**MEMORIAL MIDDLE SCHOOL MUSIC ADDITION
SIOUX FALLS, SOUTH DAKOTA**

KOCH HAZARD ARCHITECTS

ADDENDUM DATE: February 26, 2019

ADDENDUM-1

M3.1

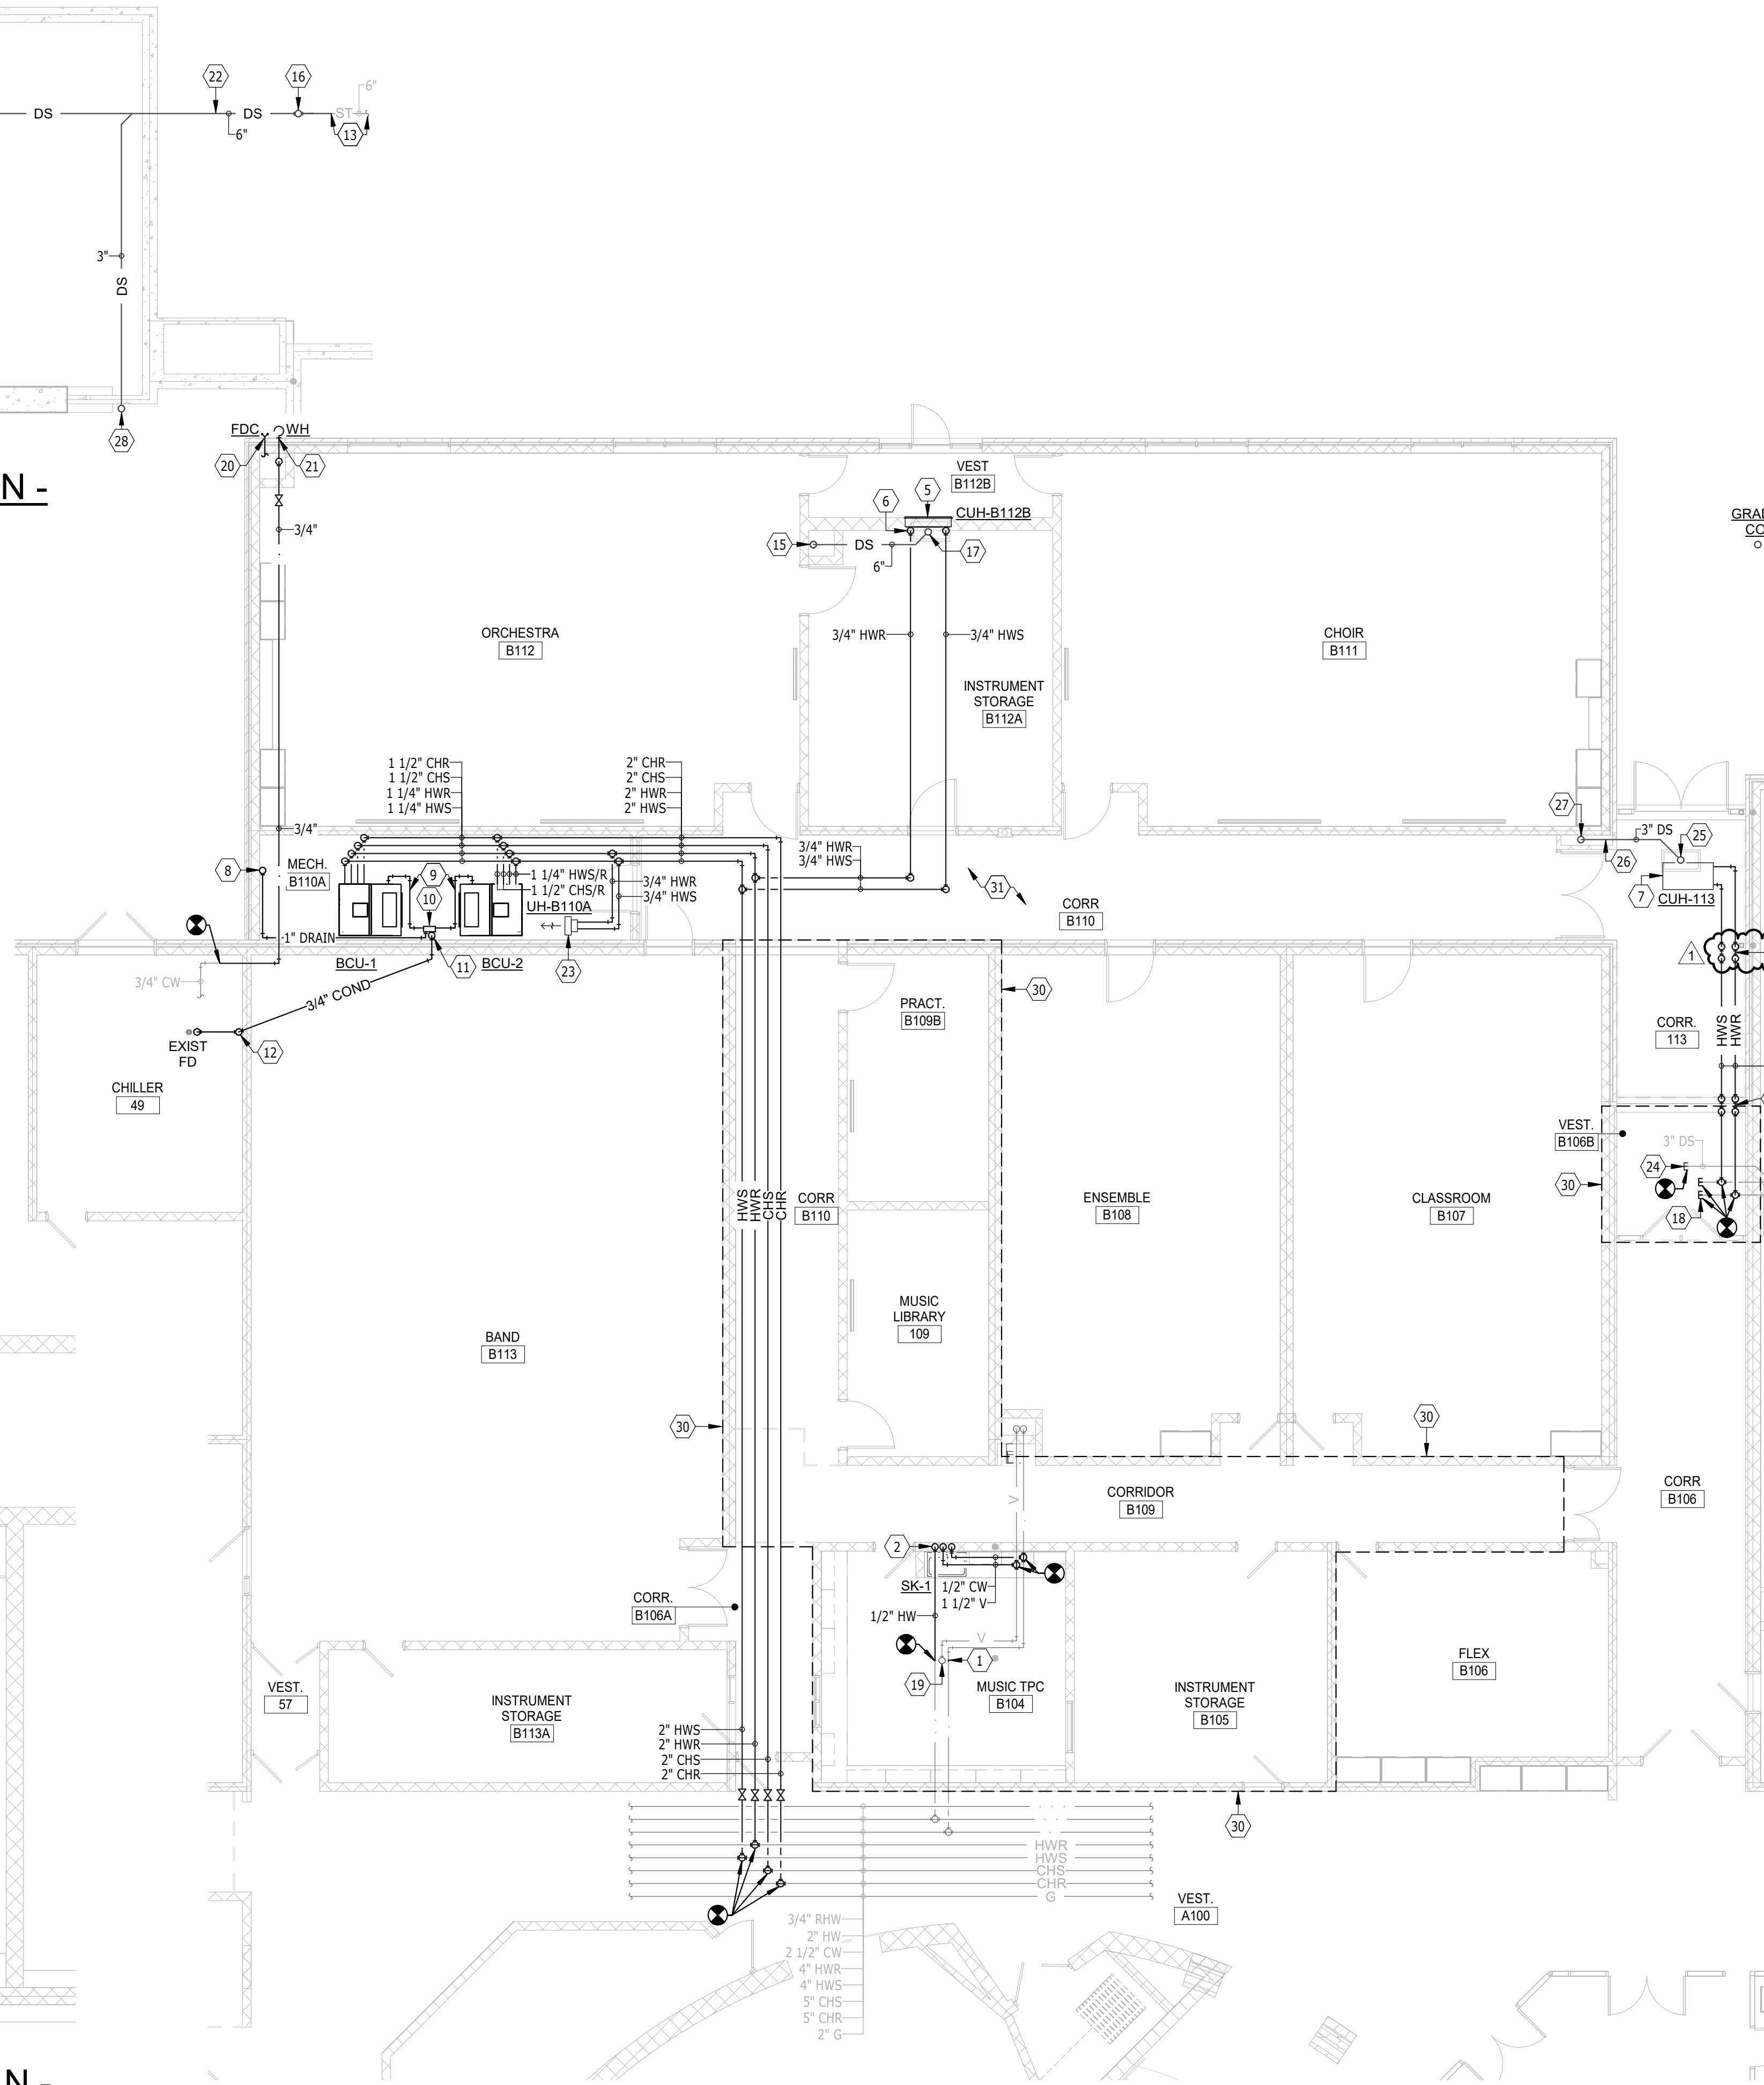
1. Revise routing of HWS/R to CUH-113 to transition piping around structure. See revised drawing sheet, dated 2/26/19.

26. ROUTE DS BENEATH BEAM IN APPROXIMATE LOCATION SHOWN.
27. 3" DS DN W/ CO 24" AFF.
28. 3" DS UP.
29. TRANSITION HWS/R IN SOFFIT TO ROUTE BENEATH EXISTING BEAM APPROXIMATELY AS SHOWN.

FLOOR PLAN – POWER & SIGNAL

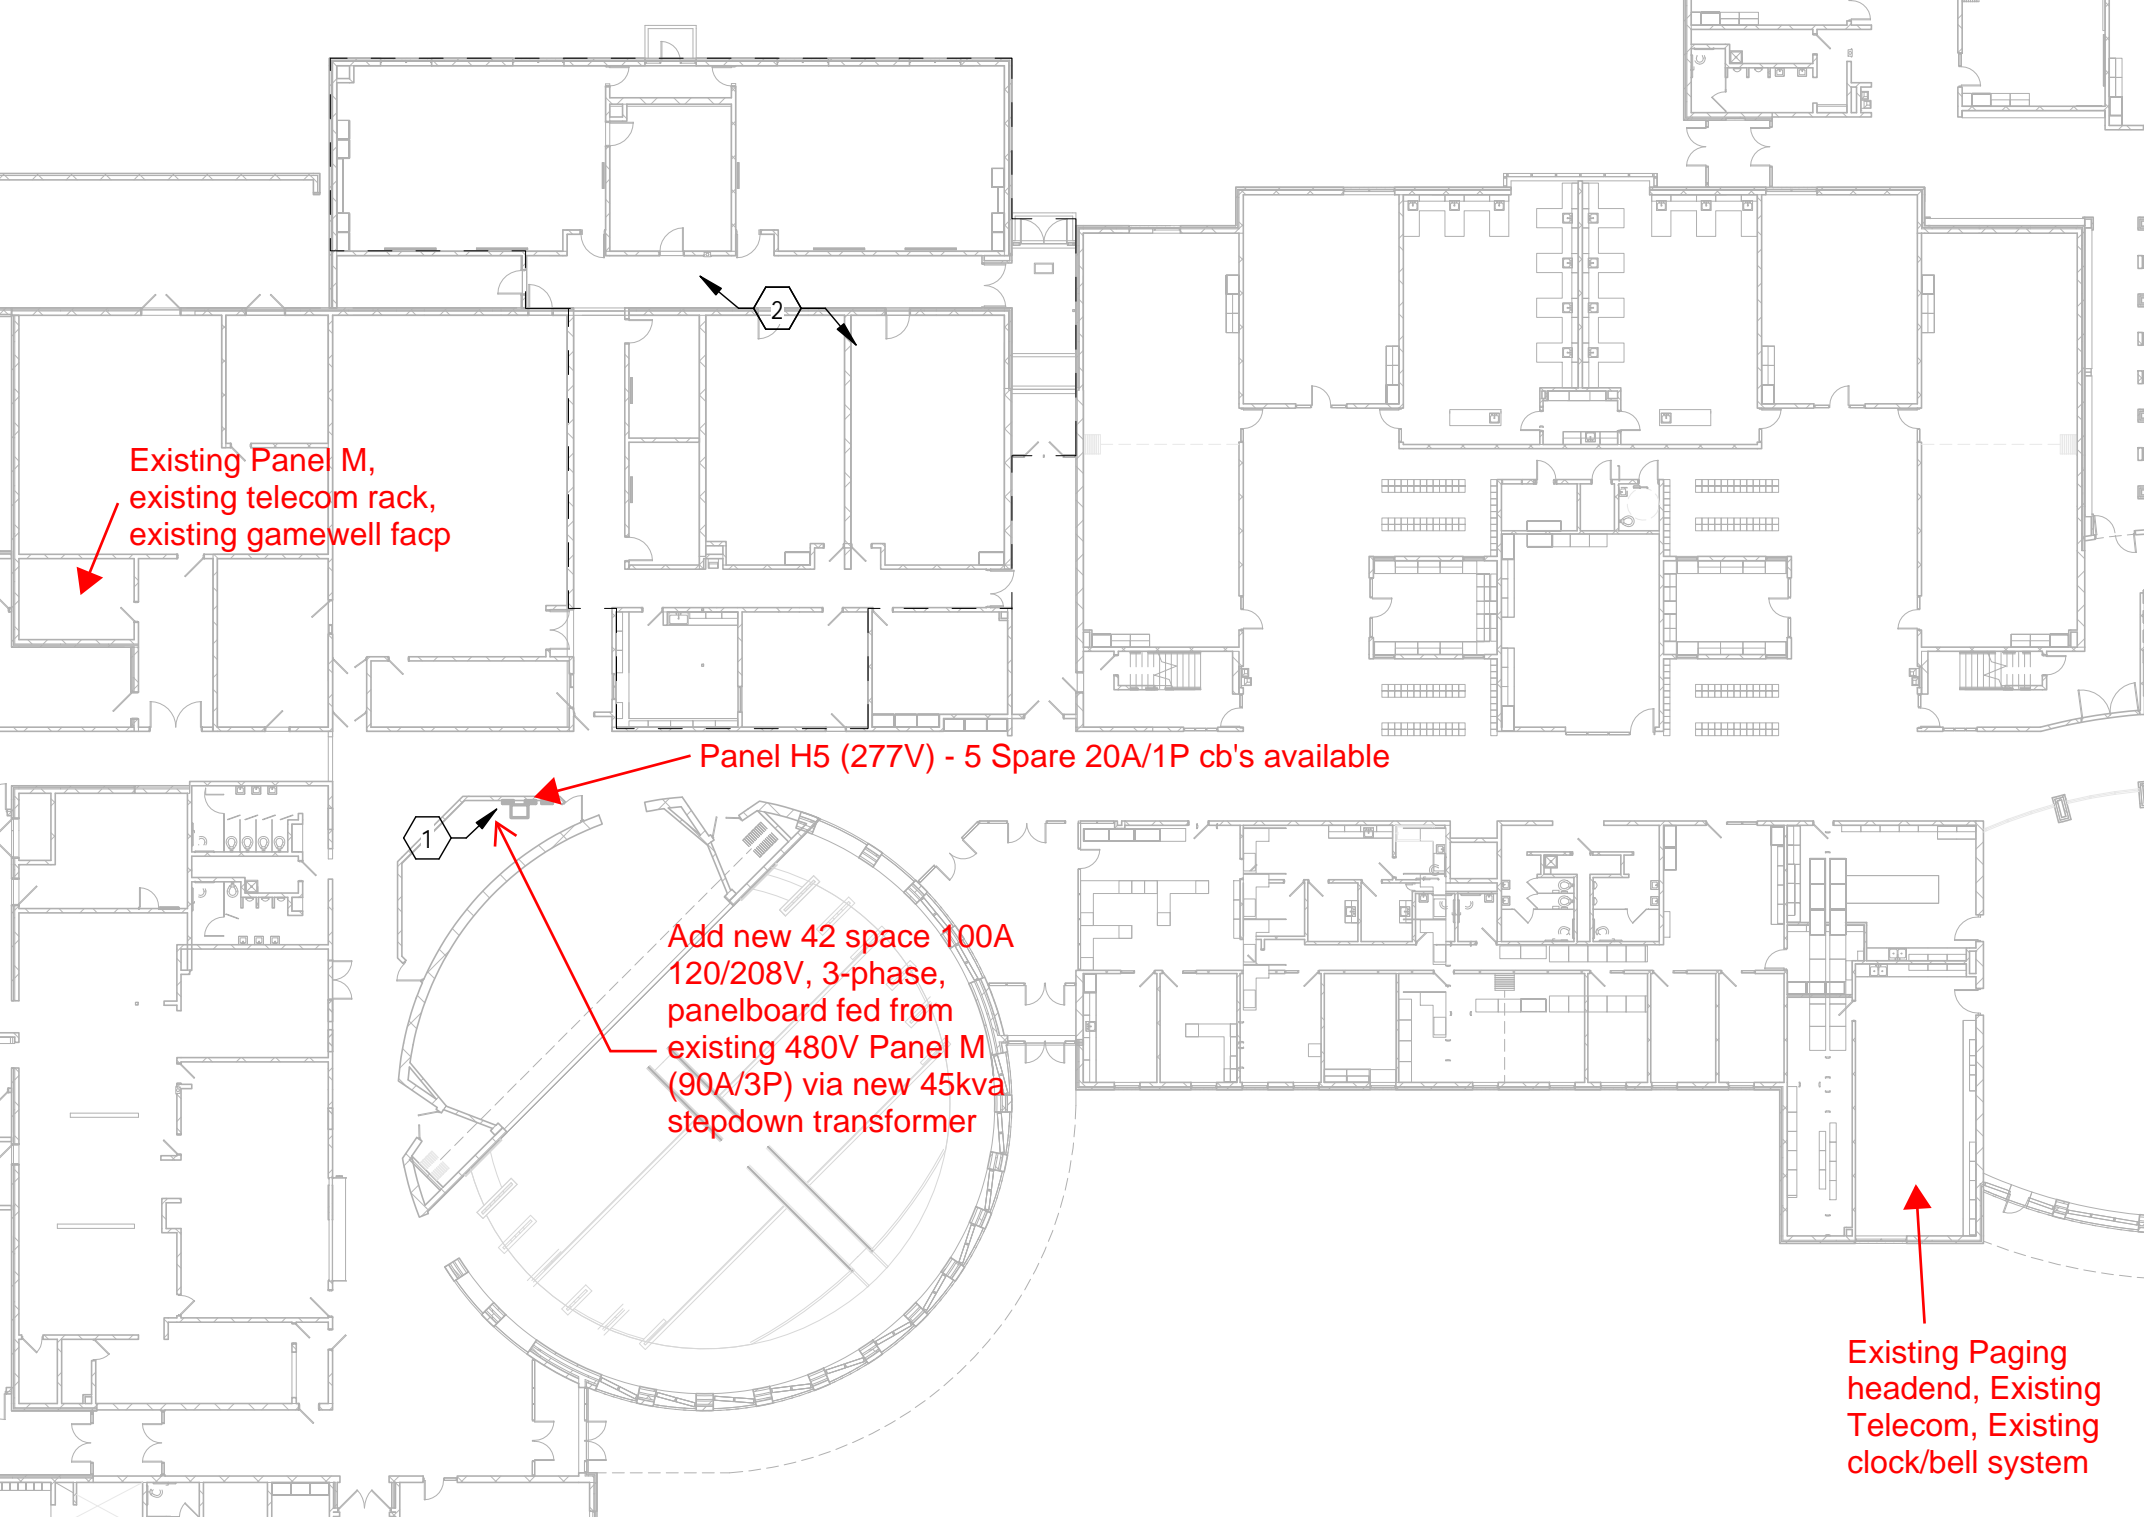
1. In lieu of using existing Panel 'L5' and existing spare circuit breakers for new loads, feed new loads from new Panel '5A' per attached panel schedule.
